## **Access Compliance Report Public Rights-of-Way** (Curb Ramps)

Intersection ID: 10019990 Main Street: ARMORY DR **Cross Street: N/A** Location: NE ADA ID: 9EDB19FF33B6 Ramp Type: PerpDiag Initial Pass/Fail: Fail **Overall Compliance: No** Severity Score: 13.75

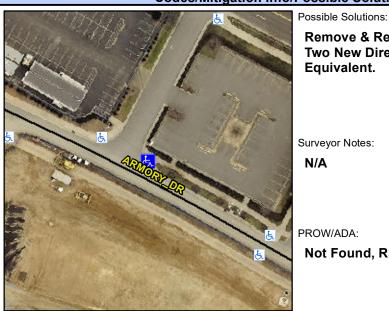
Not Found, R304.2.2, R304.5.3

Remove & Replace Curb Ramp With Two New Directional Ramps or Equivalent.
